RE: Administrative Design Review Application Case No. PADR-003469-2024 1363 E Garfield Ave

DESIGN REVIEW STAFF REPORT - SINGLE FAMILY

October 16, 2024 1363 E Garfield Ave

ADR-003469-2024 Susanna Sahakian

SOUTH ELEVATION

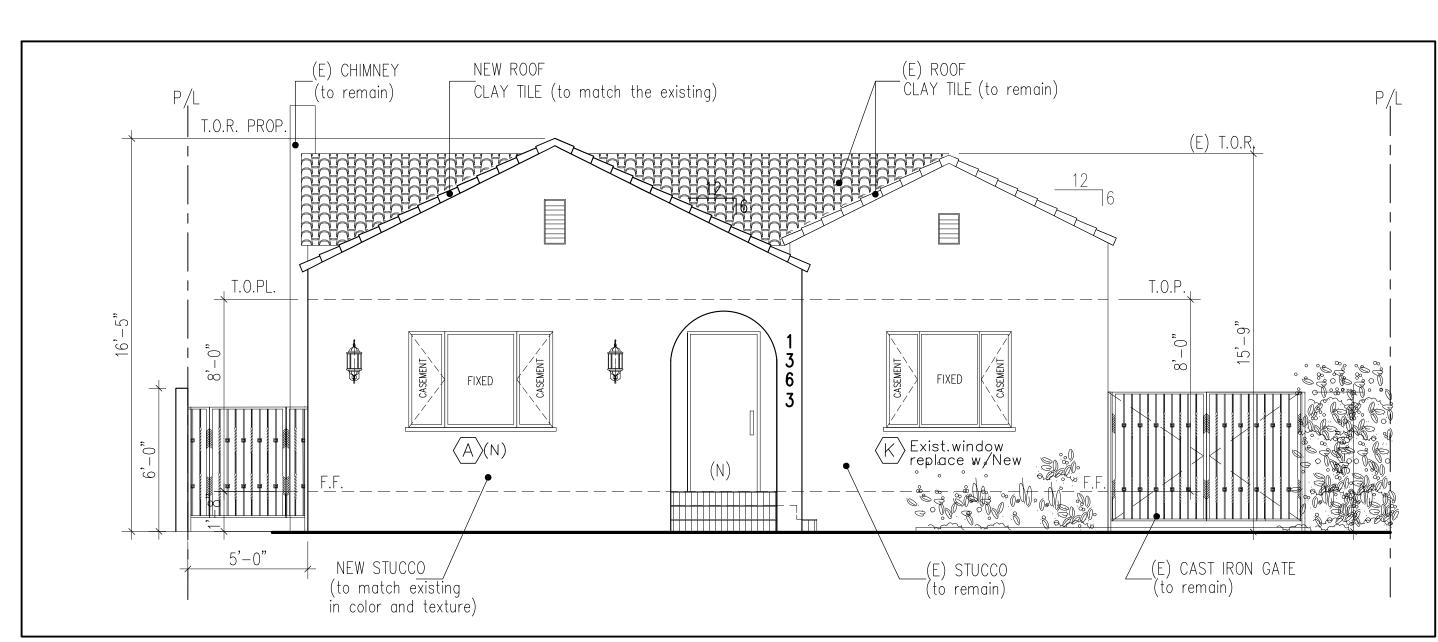
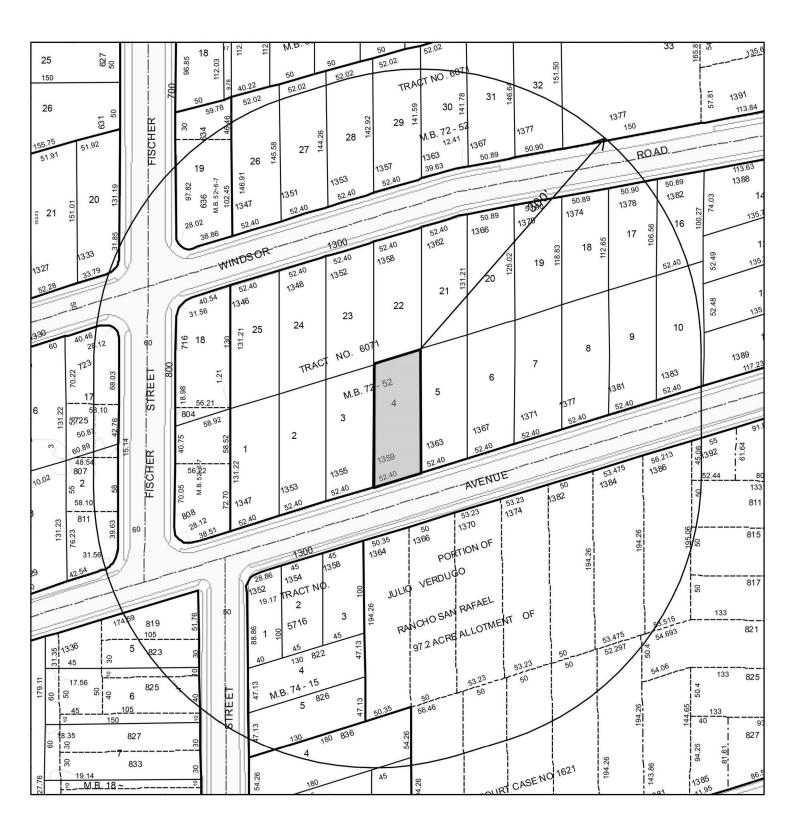
| Privacy |
|--|
| As proposed, two light fixtures will result in an over-lit street-facing facade. The exterio lighting shall be limited to their location to the main entry, egress door, and vehicle |
| entrance. A condition is included to plan only one light fixture on the street-facing south |
| facade, and another light fixture may locate on the west facade either on or under the |
| covered patio. |

- The exterior lighting fixtures shall be limited to their location to the main entry, egress door, and vehicle entrance. Plan only one light fixture on the street-facing south facade, and another light fixture may locate on the west facade either on or under the covered patio.
